Re: 42 Ridge Avenue
Map 27 Block 724 Lot 25
Jaime Martinez (owner/applicant)
Zone: R-1B, Single Family Residence District

This application requests variance relief for the installation of a rear yard shed at the subject property prior to procuring the required permits.

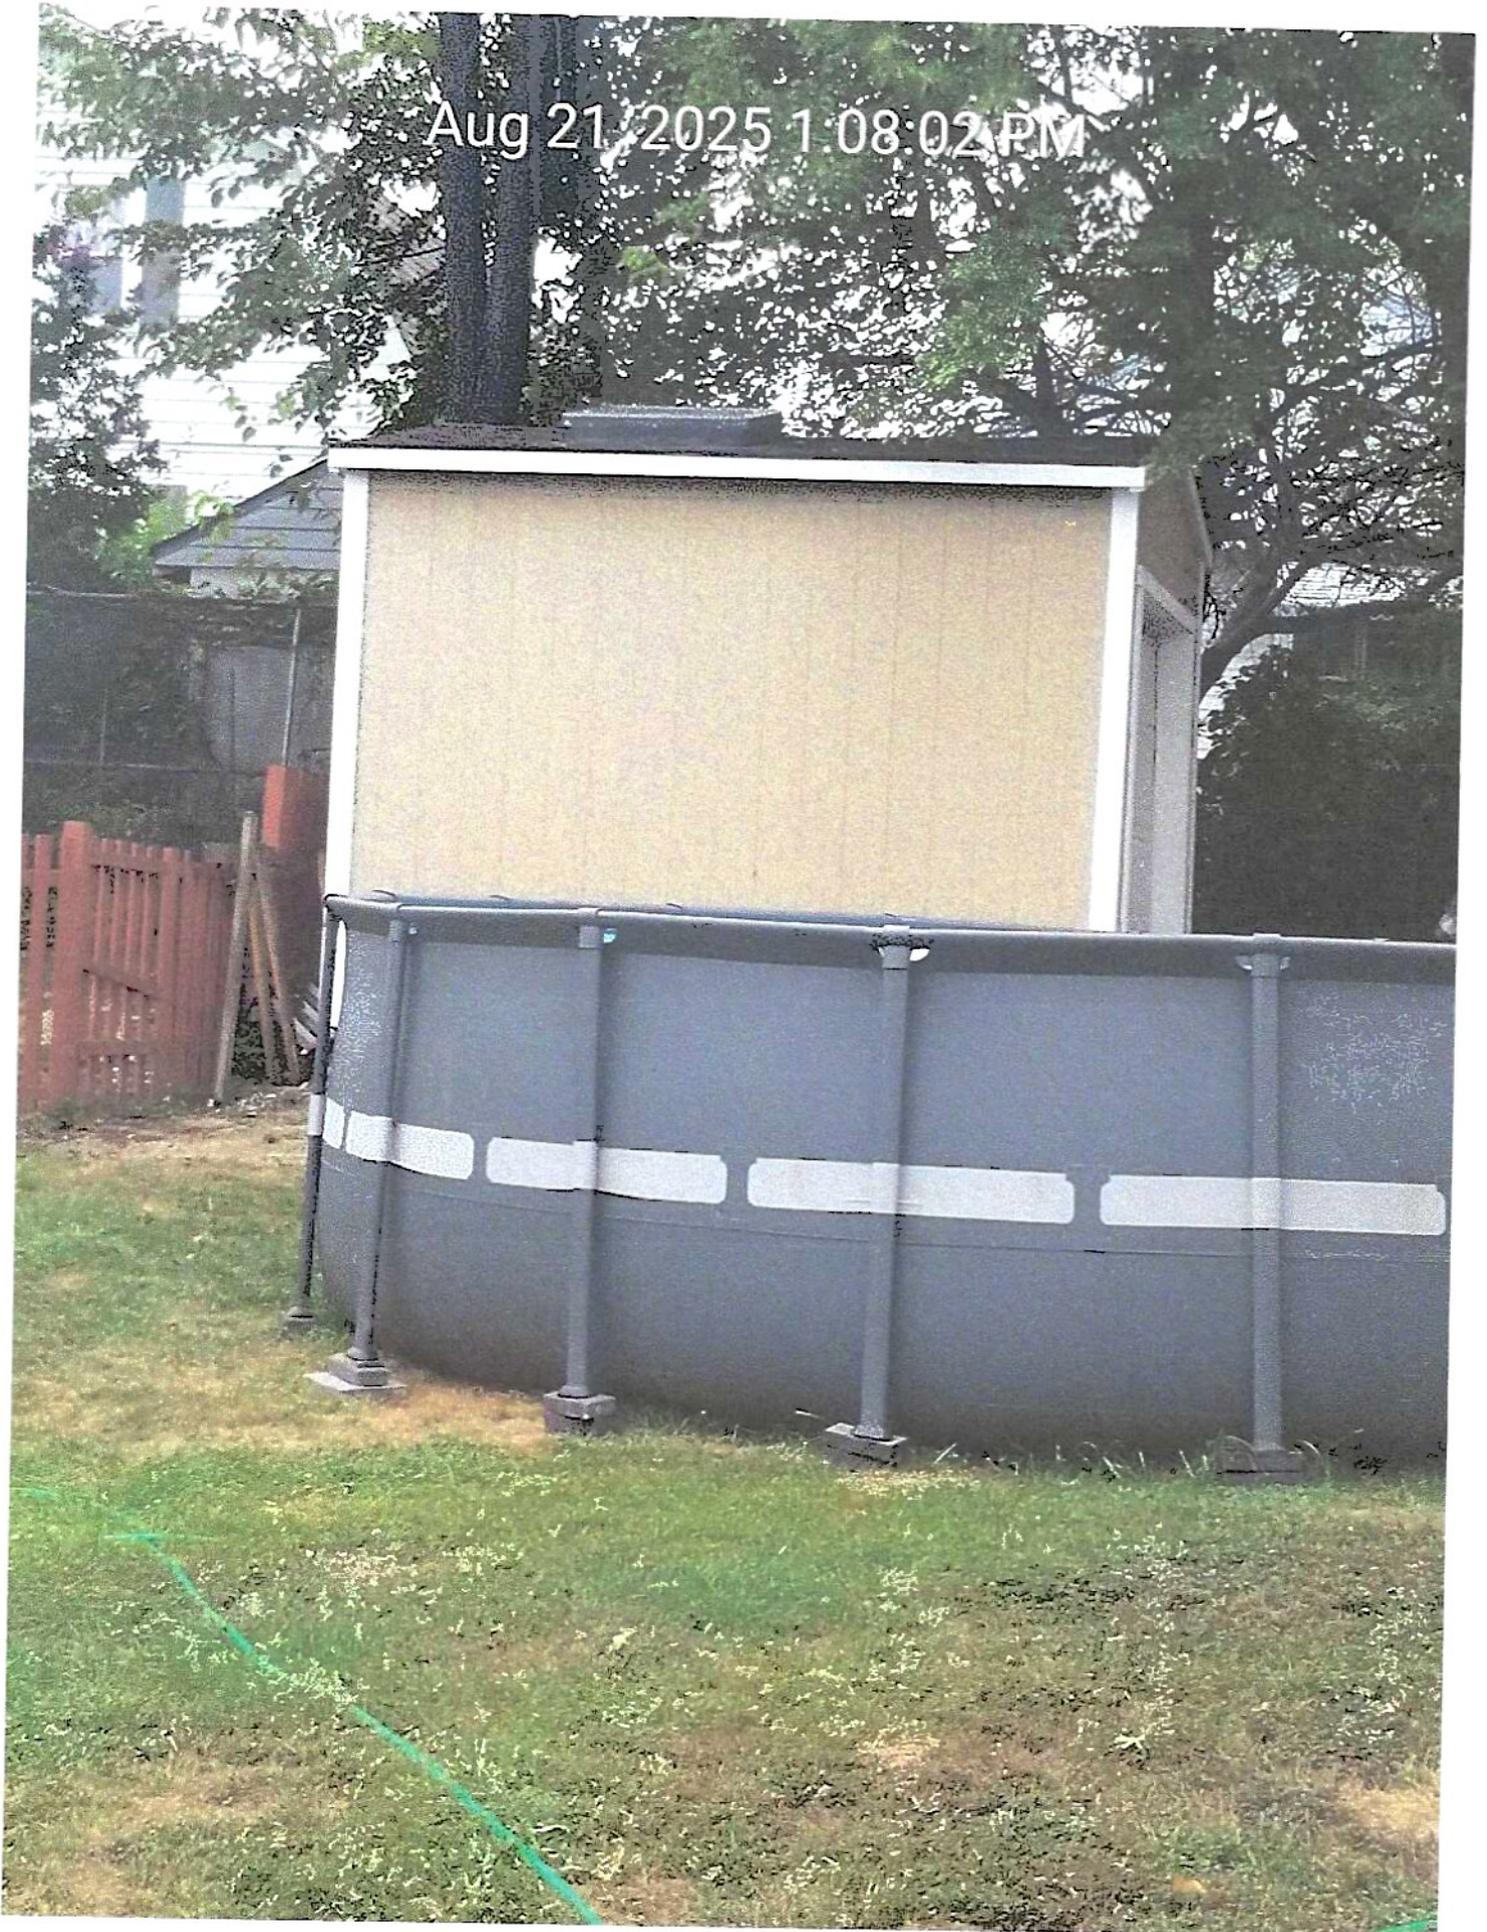
The shed is constructed in the northwesterly rear corner of the subject property.

The shed measures, by scale, twelve (12) feet wide by eleven (11) feet depth, for an area of 132 square feet.

The shed has a side yard setback of 4.1 feet and a rear yard setback of 1.0 feet.

Attached to the shed is a platform measuring, by scale, ten (10) feet wide by eight (8) feet depth.

The property survey also shows a brick patio situated at the northeasterly rear corner of the property, abutting the side and rear property lines.

The patio measures, by scale, fourteen (14) feet wide by ten (10) feet depth.

Section 315-36(B)(2). No accessory building shall exceed 80 Square feet.
The existing shed measures 132 square feet.
Class C Bulk variance relief is required.

Sheds require a minimum side yard and rear yard setback of five (5) feet.
The shed has a 4.1 feet side yard setback and a 1.0 feet rear yard setback.
Class C Bulk variance relief is required.

Decks, patios and terraces are regulated pursuant to Section 315-36(D)(4).
The rear brick patio is setback along the side and rear property lines.
All decks, patios and terraces shall be located in the rear yard only and must meet the required setbacks for principal buildings.
Class C Bulk variance relief is required.

- Testimony shall be provided in support of the required variance relief.
- Testimony shall be provided to determine if the shed can be moved or otherwise relocated to comply with the required minimum side and rear yard setbacks.
- Testimony shall be provided with respect to the proposed use of the shed, given the oversized 132 square feet of space, the need for a roof skylight, and any existing or proposed utilities.
